寄件者: AI TSANG <[REDACTED]>
寄件日期: 2026年04月08日星期三 12:50
收件者: Cheryl Tsz Man TSANG/PLAND
主旨: Re: Planning Application No. A/NE-MKT/60 Temporary Open Storage of Metal
Scaffolding with Ancillary Office for a Period of 3 Years
附件: A-NE-MKT-60 GPRR 4-4-2026 (1).pdf; MKT-60 response to comments 2.pdf
類別: Internet Email

Geotechnical Planning Review Report

For Planning Application: Temporary
Open Storage of Metal Scaffolding with
Ancillary Office for a Period of 3 Years at
Lot 751 S.B RP in D.D. 82, Ta Kwu Ling
(A/NE-MKT/60)

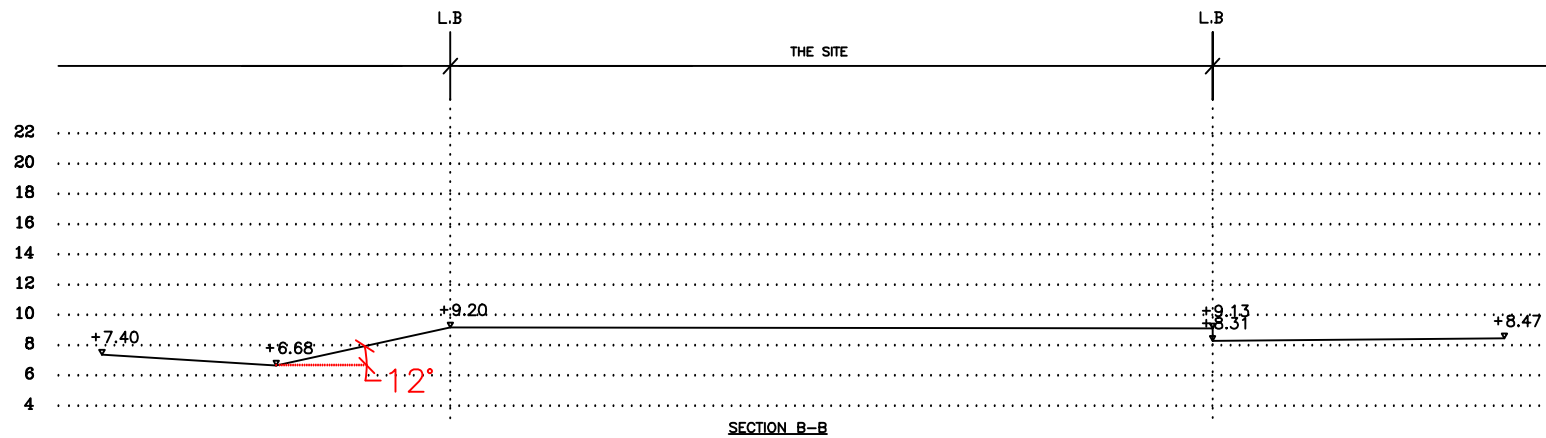
During the site visit, his office noted that there were suspected unauthorised works (USW) involving a filling platform with concrete pavement of about 1.5m to 2.0m high. Since the application site will affect and be affected by the USW, and in order to ensure the safety of the future users, the subject planning application is not supported at this stage until the necessary remedial/reinstatement actions are completed to the satisfaction of the relevant government departments (for example the Buildings Department and Environmental Protection Department).

Consider Section A-A, there is an existing slope in the western side of the site (the buffer zone) with crest level at +9.20mPD. The shadow angle is 22.0degree (<25degree), according to TGN15, this slope would not affect the existing temporary structures. And the existing temporary structures is at toe side, it would not affect the site. In the eastern side of the site, the level difference is 2.67m (H=2.67m) and the crest is 4.15m away from the site (D=4.15m), according to TGN15, this level difference would not affect the site. Therefore, the proposed development would not adversely affect any geotechnical feature.
